ADDENDUM NO. 1 TO ALL BIDDERS:

Reference – Invitation for Bid:	IFB #015-0-2025/SNB Yates Elementary School Security Vestibule and Office Addition & Alterations
For Delivery To:	Newport News Public Schools
Bids Due:	March 27, 2025 at 2:00 PM EST

## ADDENDUM NO. 1

#### Yates Elementary School Security Vestibule and Office Addition & Alterations

A4.01

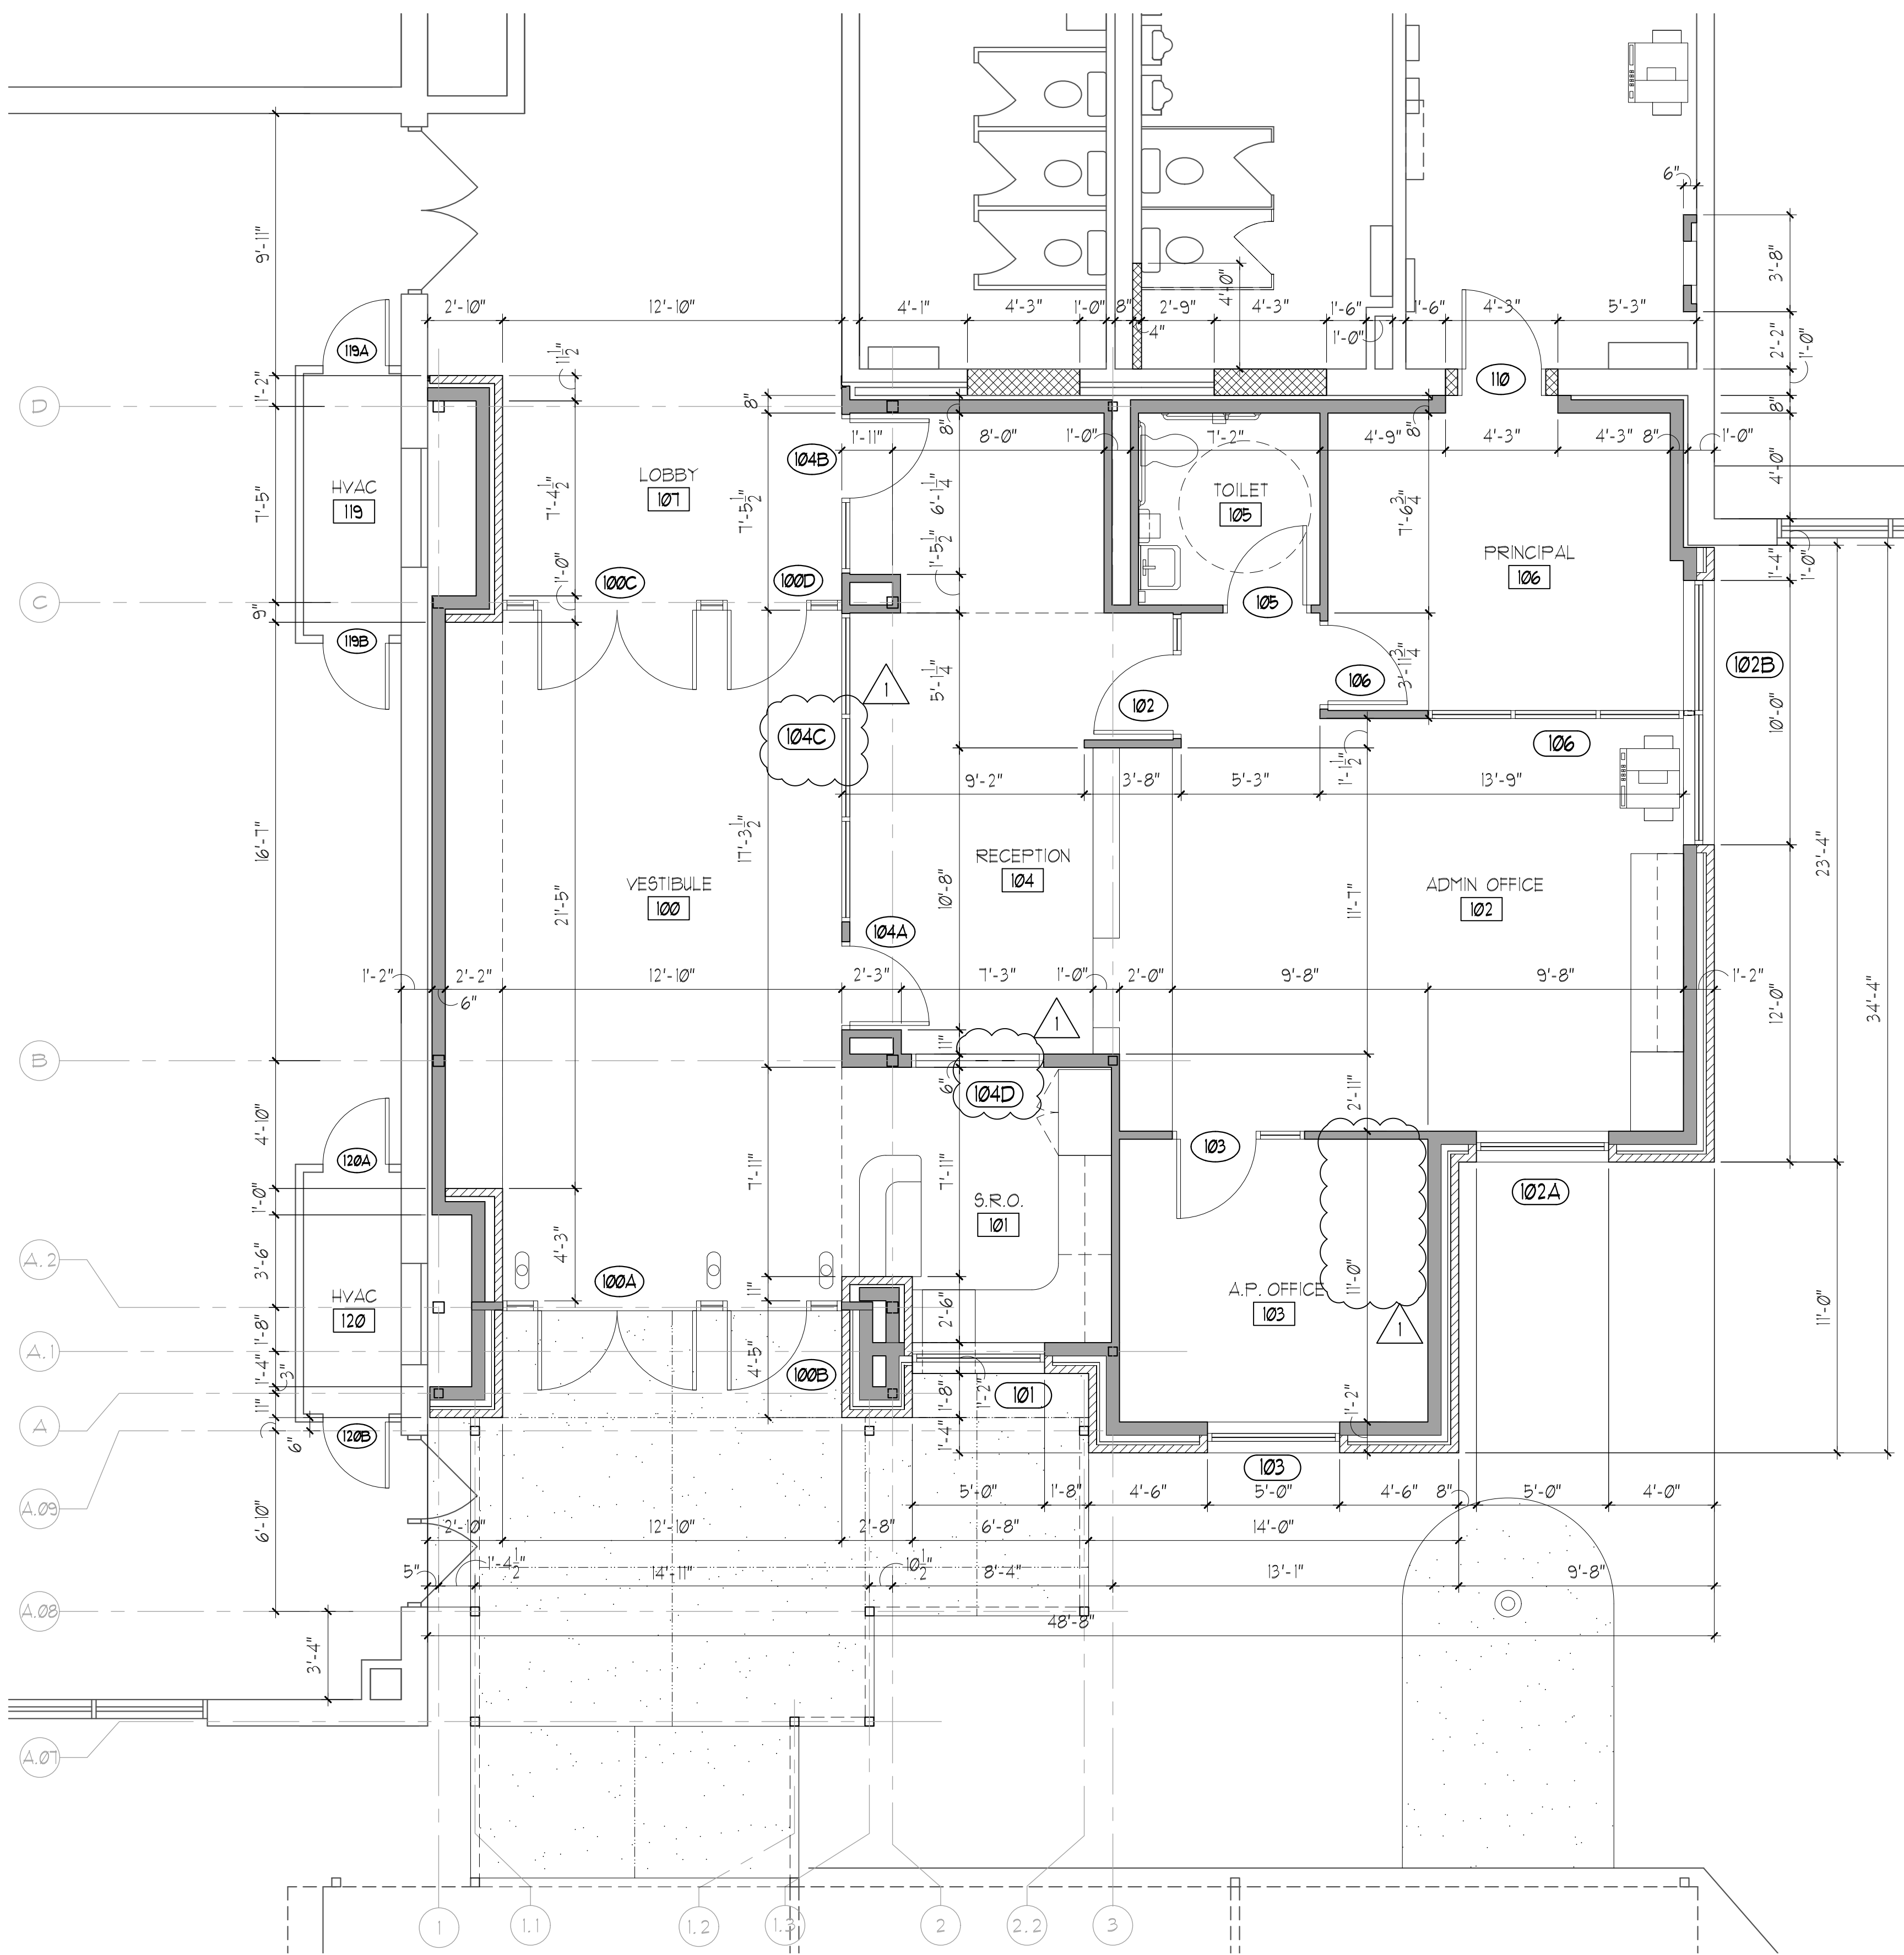
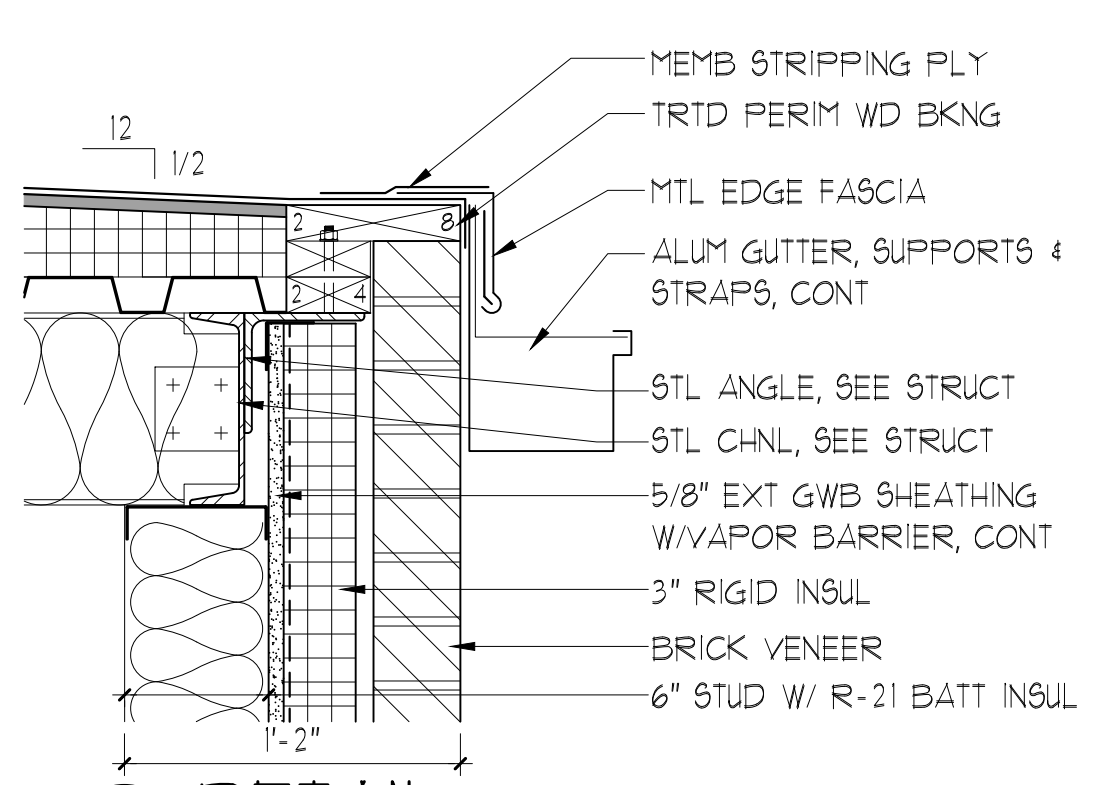
8. Architectural Drawing A4.01: This drawing has been revised to include:
  - a) Omission of casework shown in Assistant Principal's Office, Room 103.
  - b) Revision of window designation labels at the Reception Area Room 104.

A4.02

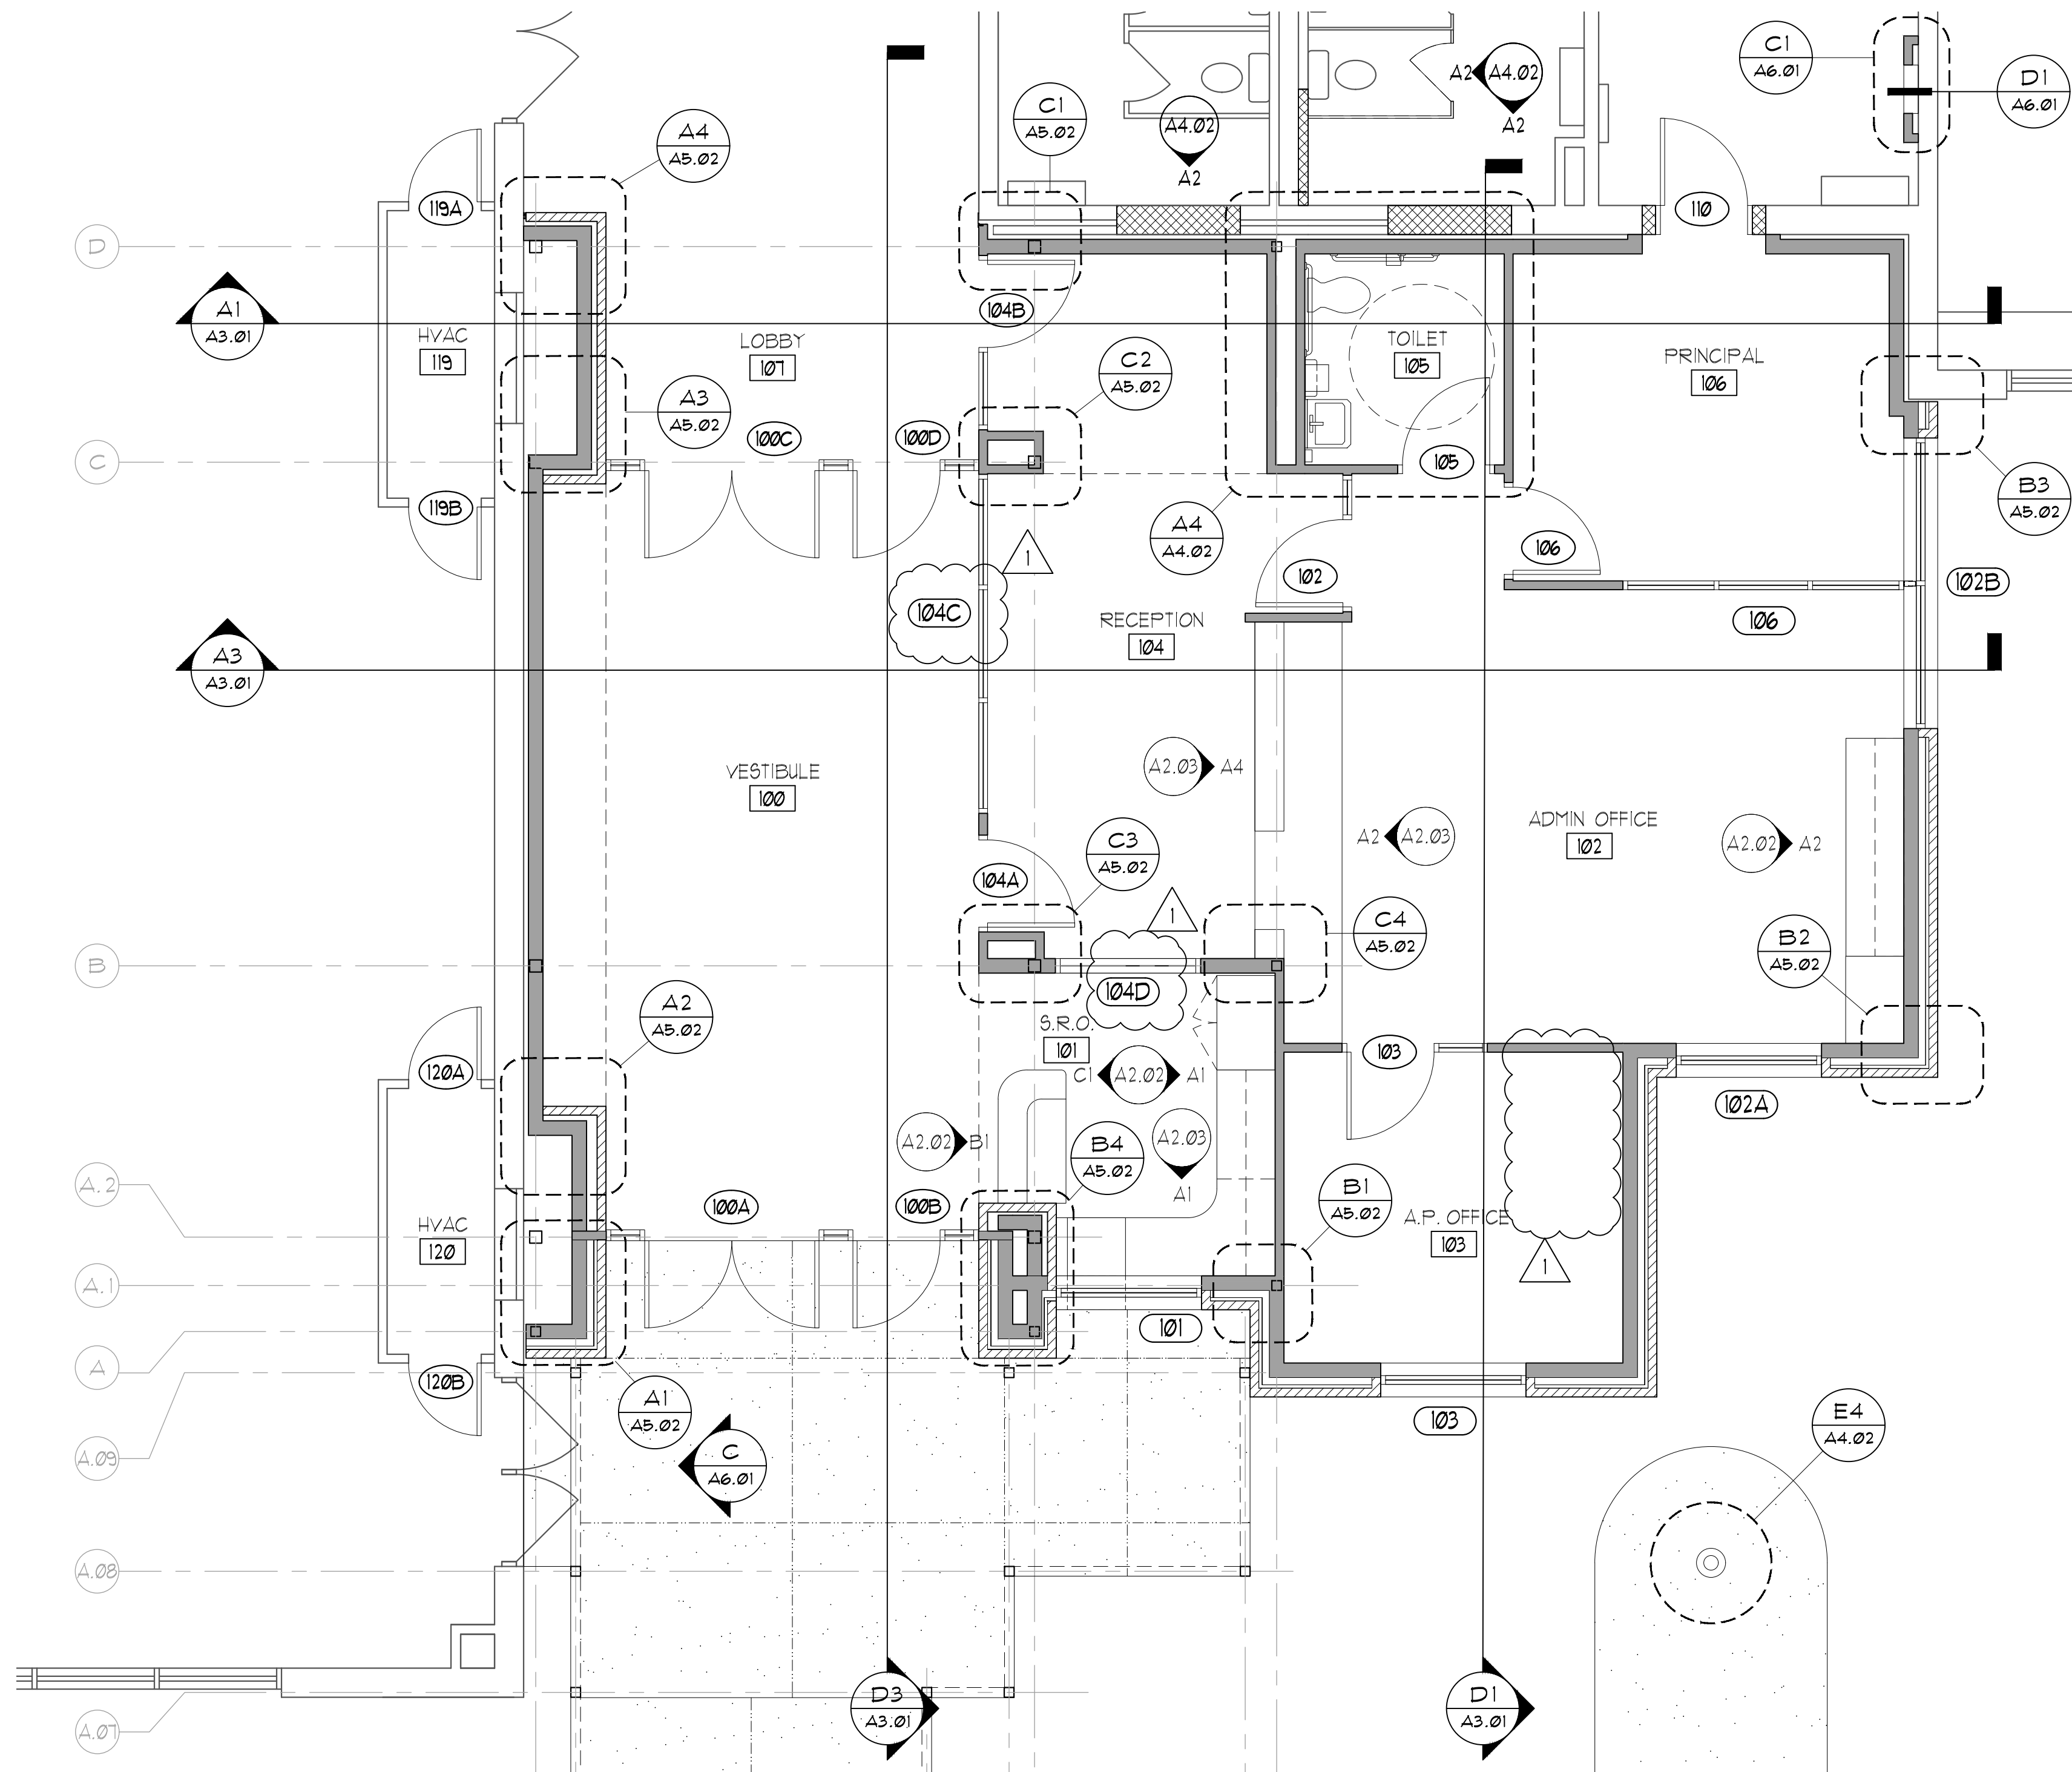
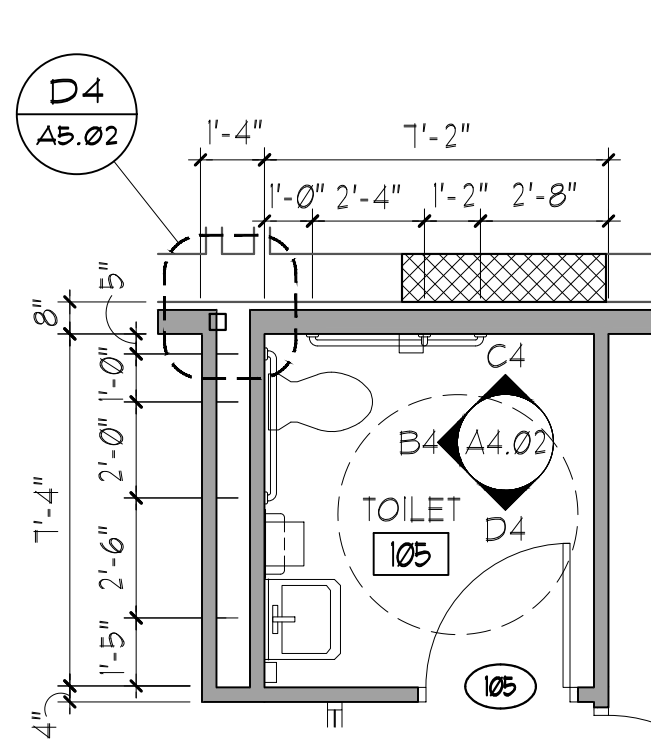
9. Architectural Drawing A4.02: This drawing has been revised to include:
  - a) Omission of casework shown in Assistant Principal's Office, Room 103.
  - b) Revision of window designation labels at the Reception Area Room 104.
